### STAFF RECOMMENDATION

1517 Paris Avenue

February 20, 2013

**Application:** New construction – detached accessory dwelling unit

Roof Plan of Recent Addition

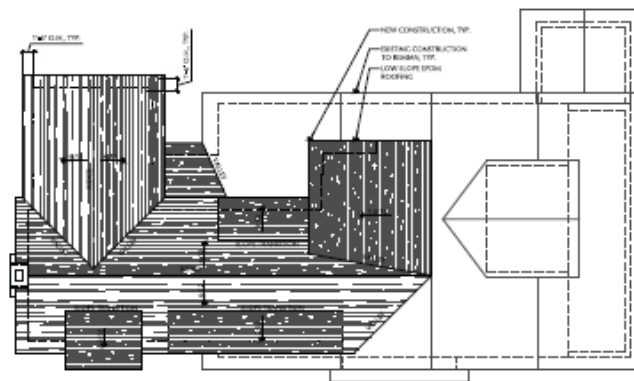
With the recently constructed two-story addition, the footprint of the primary building has a footprint size of two thousand, three hundred, ninety-seven square feet (2397 sq. ft.) leaving sixty-four percent (64%) of the lot remaining as open space. The DADU would bring the proportion of open space down to only fifty-five percent (55%).

By comparison, on nearby lots with historic houses and accessory buildings, the typical amount of open space is around seventy-two percent (72%). The lot at 1511 Paris Avenue has a lower amount of open space at sixty-one percent (61%), but it has a larger than average house and a smaller than average lot. A non-historic house at 1507 B Paris Avenue, constructed before the Neighborhood Conservation Zoning Overlay went in place, has the lowest amount of open space nearby with sixty percent (60%). The percentage of open space is easiest to calculate based on lot coverage alone but the massing of the structures on the lot should also be considered as “open” space is not just about green space. Although the proposed building is minimal, the rear addition recently added has two-stories and a partially above-ground basement. The additional height was allowable due to the drop in grade which kept the bulk of the addition hidden behind the primary building. The massing of the addition and the lot coverage of the full project, existing and proposed, all together significantly decrease the open space well below that found historically.

Because the lot already has little open space remaining compared to the historic properties nearby, and because the construction of the proposed DADU would leave the lot with the lowest proportion of open space among all nearby properties, both contributing and non-contributing, staff finds that the proposed DADU does not meet guideline II.B.1.b.

Rear Addition at 1517 Paris Avenue. Dumpster on left is in approximate location of proposed DADU.

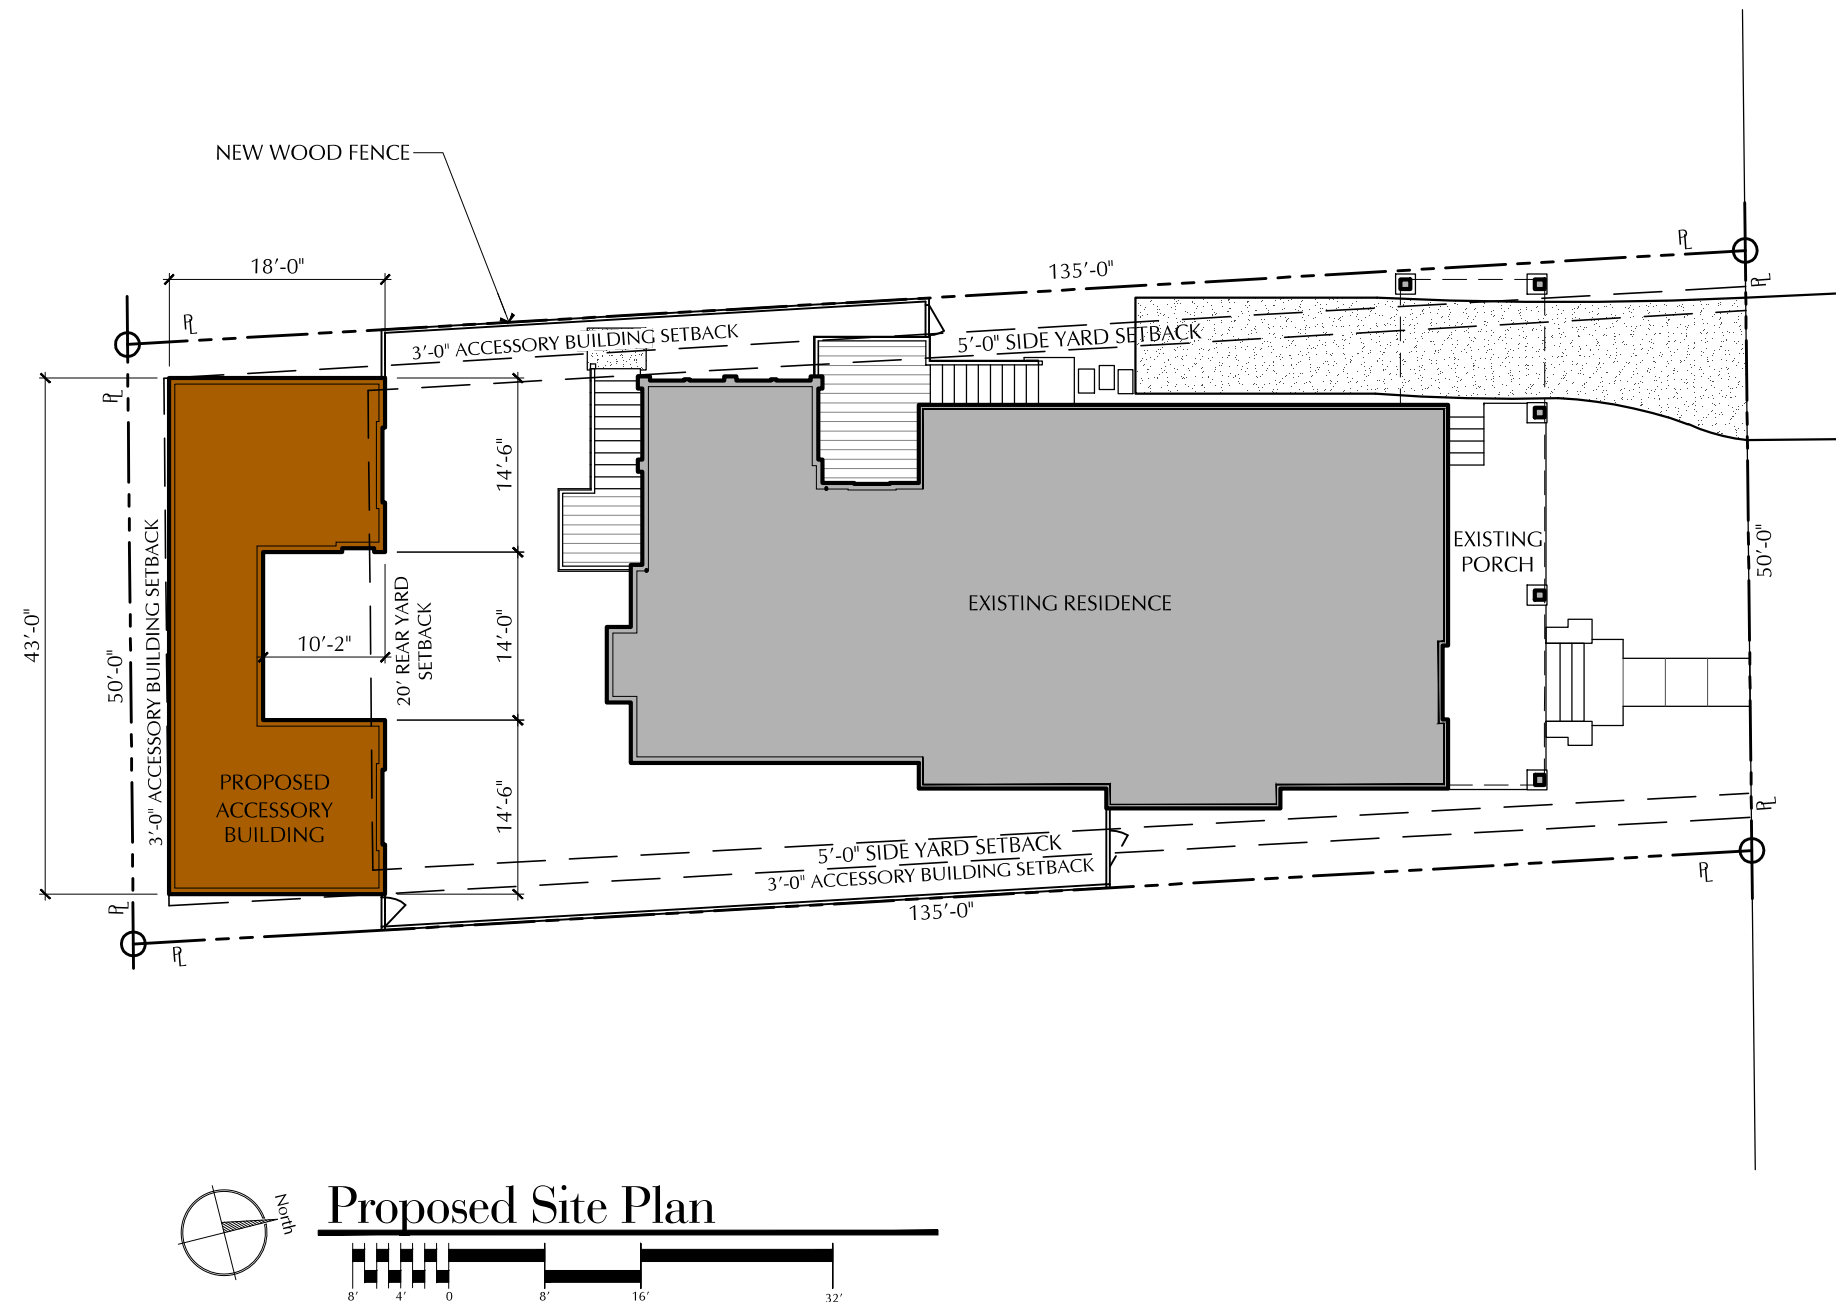
The building is located at the rear of the lot as required by the design guidelines and the DADU standards. There is no vehicular access or associated parking. The building is setback more than the minimum of ten (10') from the primary house as required by the standards.

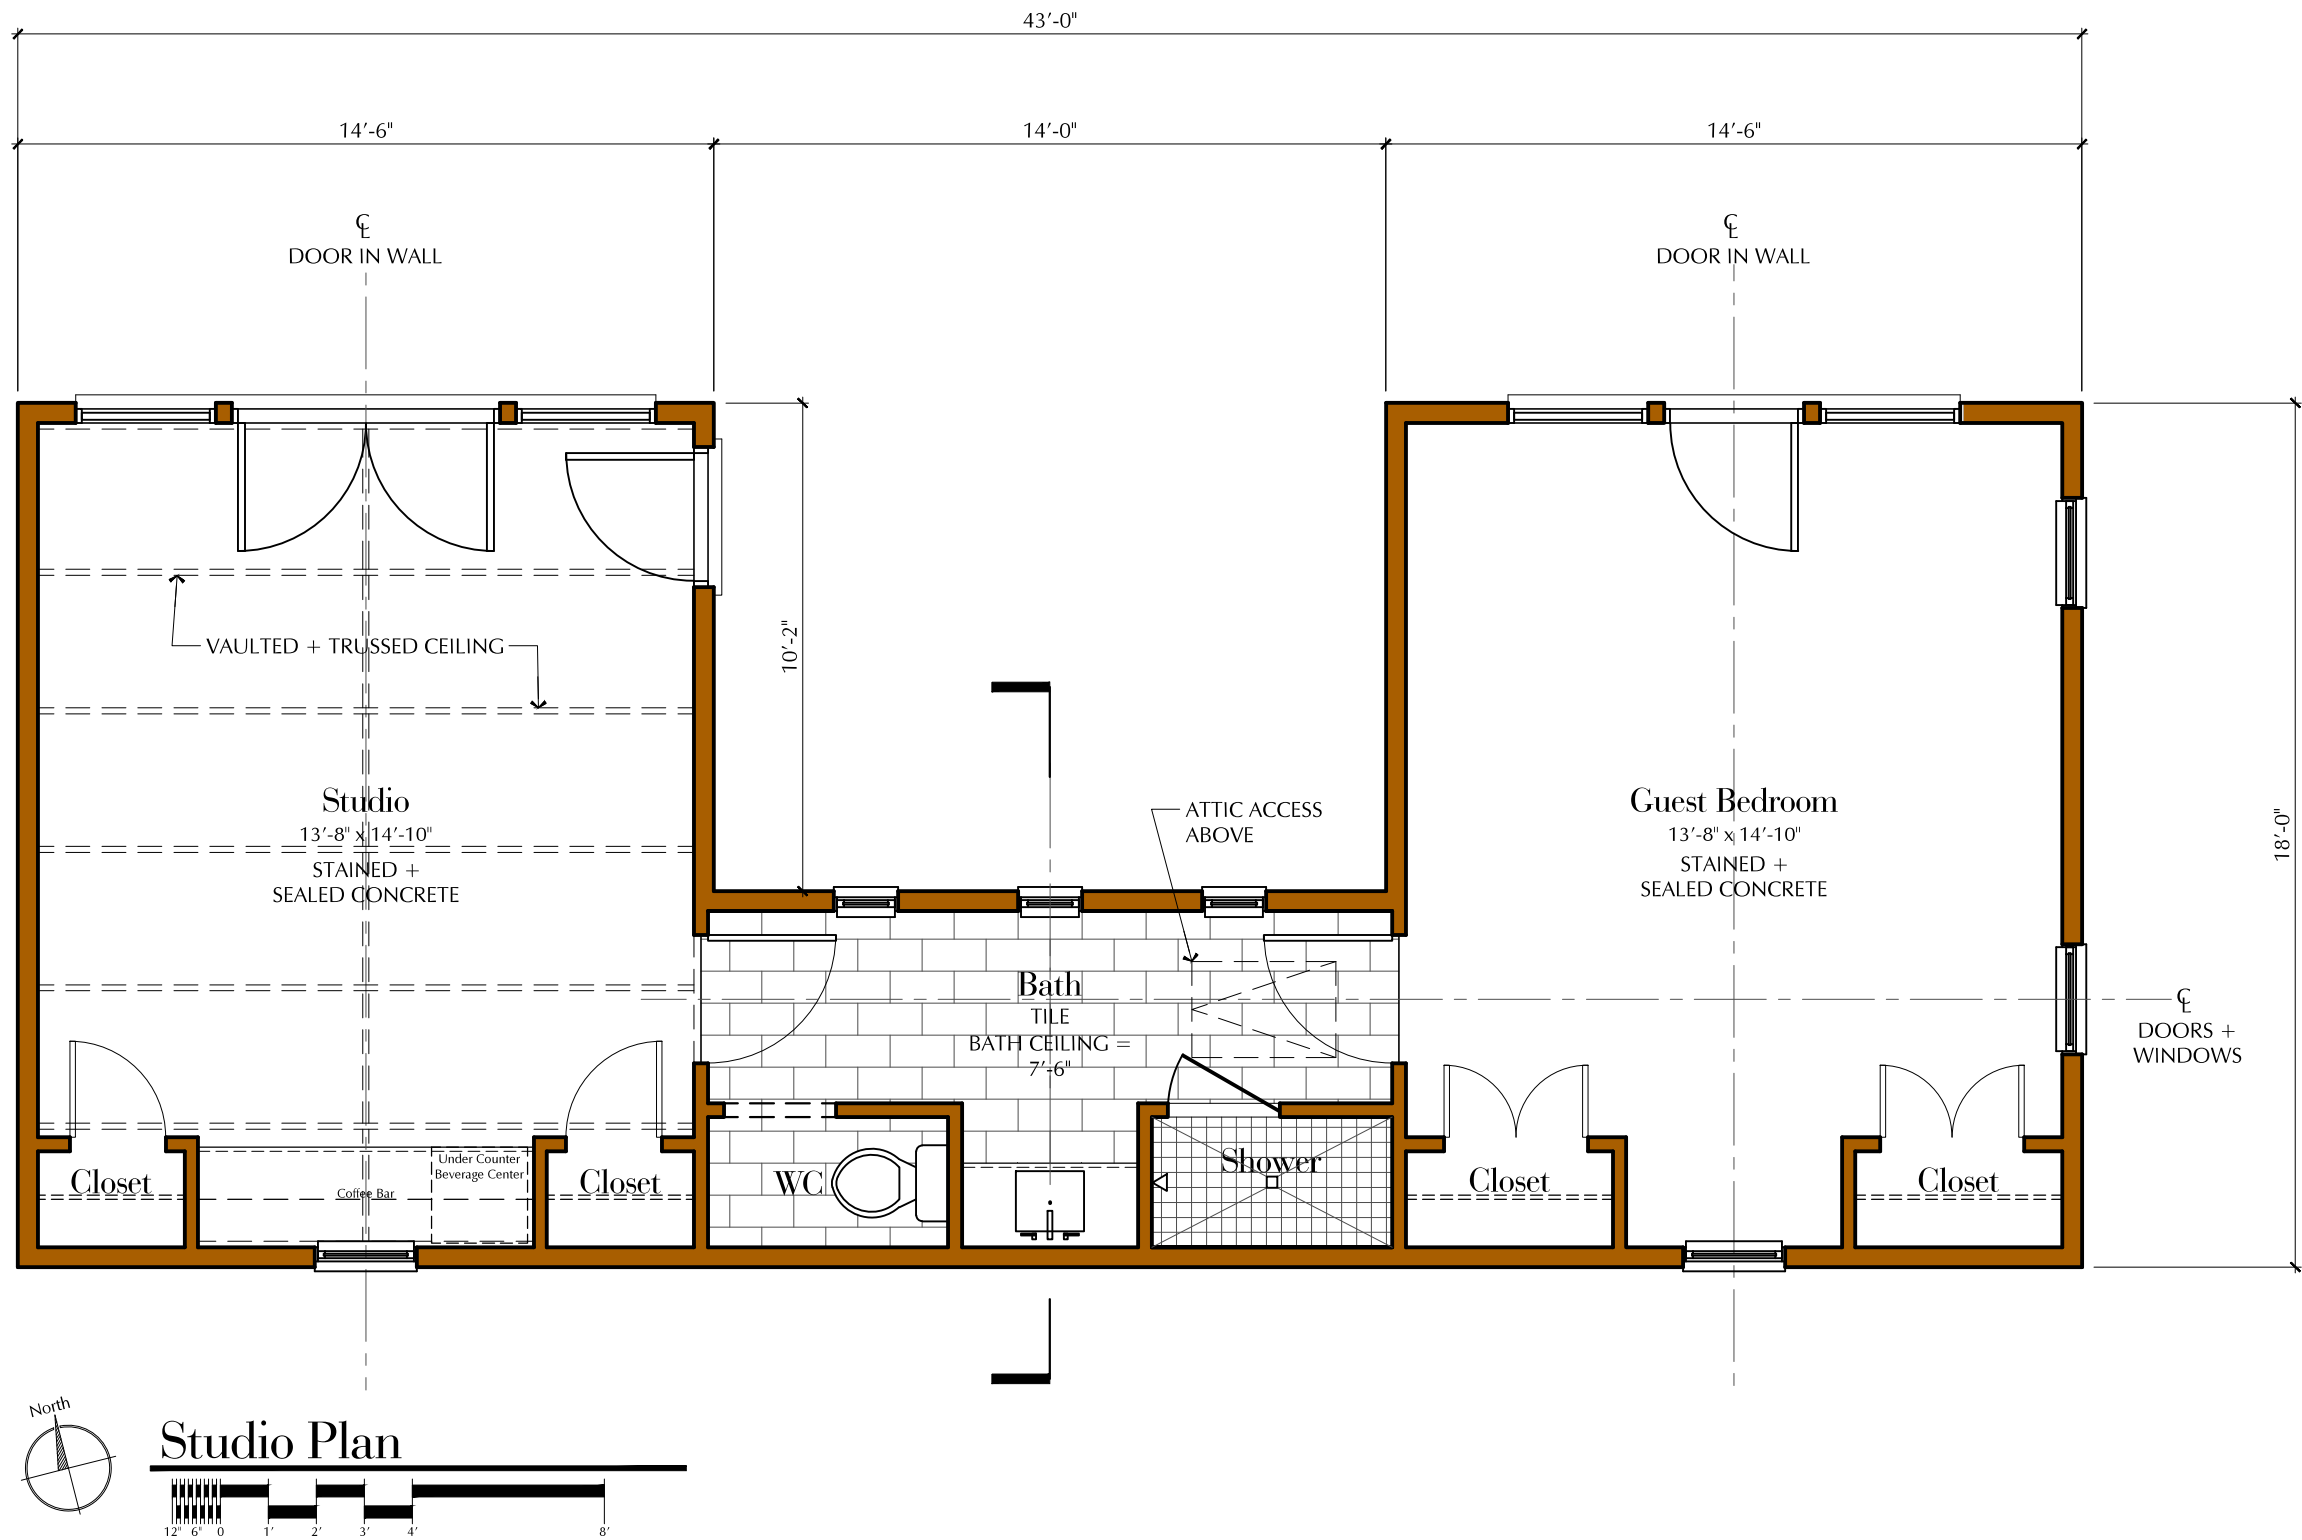
The floor plan of the building will be U-shaped, with a footprint size of six hundred, eighteen square feet (618 sq. ft.), which is less than the required maximum of seven hundred square feet (700 sq. ft.).

Rear Elevation (South)

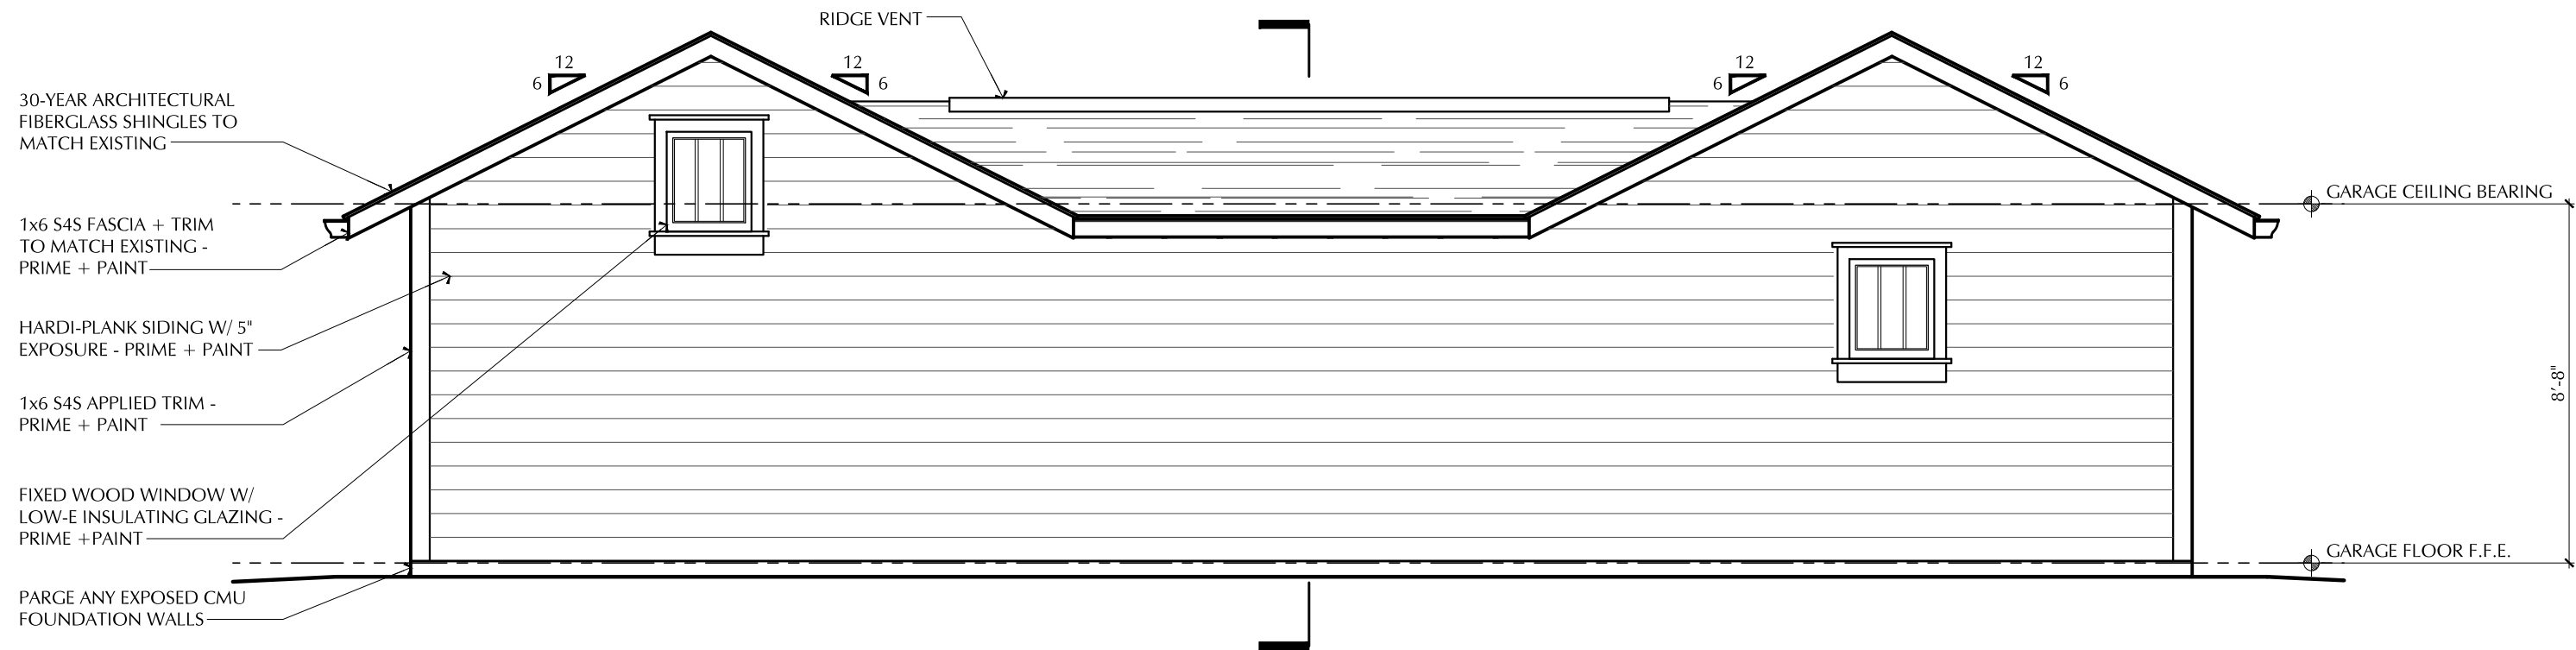
The proportion of the majority of the windows and their placement is similar to what is found on the house with the exception of the rear elevation facing the alley. Typically, the commission has been more lenient about window requirements on outbuildings when they are located at the rear of the lot.
